S/D - Lot 9, Pcl. B, D.L. 909, Pl. 9769

RE: Subdivision of Lot 9, Parcel B,
District Lot 909, Plan 9769, Phase II

LEGAL DESCRIPTION: Subdivision of Lot 9, Parcel B, D. L. 909, Plan 9769,
Phase 2. (16 Lots)

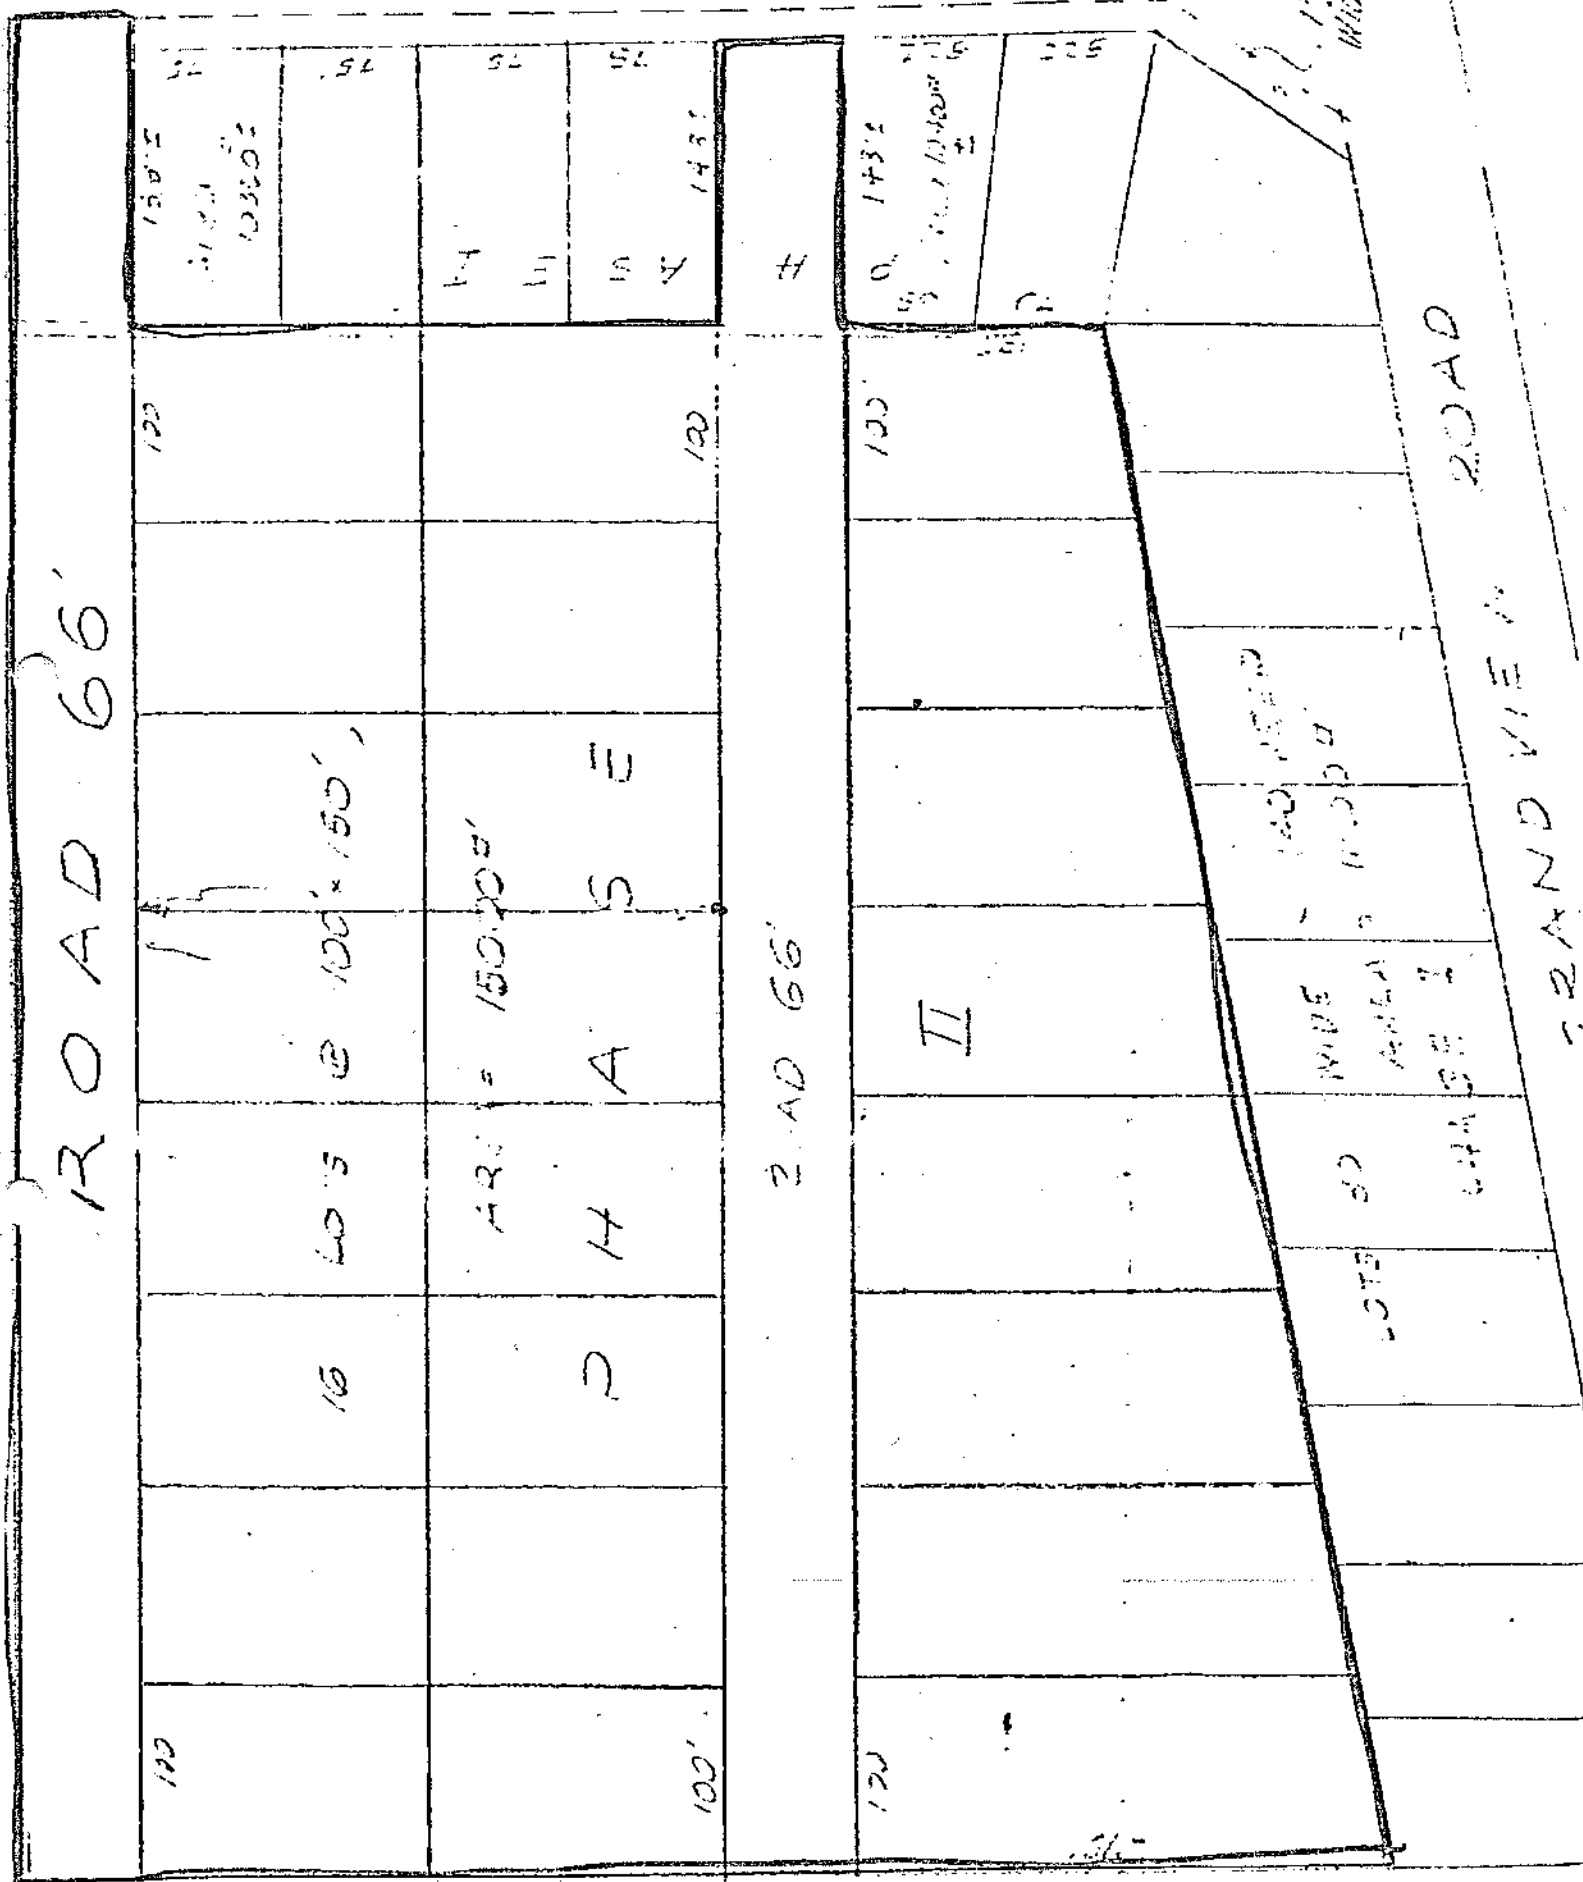
Recommend approval subject to.

- 1) Dedication of subdivision roads 66 feet wide - constructed 28 feet with 3/4 shoulders, and paved 22 feet.
- 2) all lots > 7500 sq. feet area.
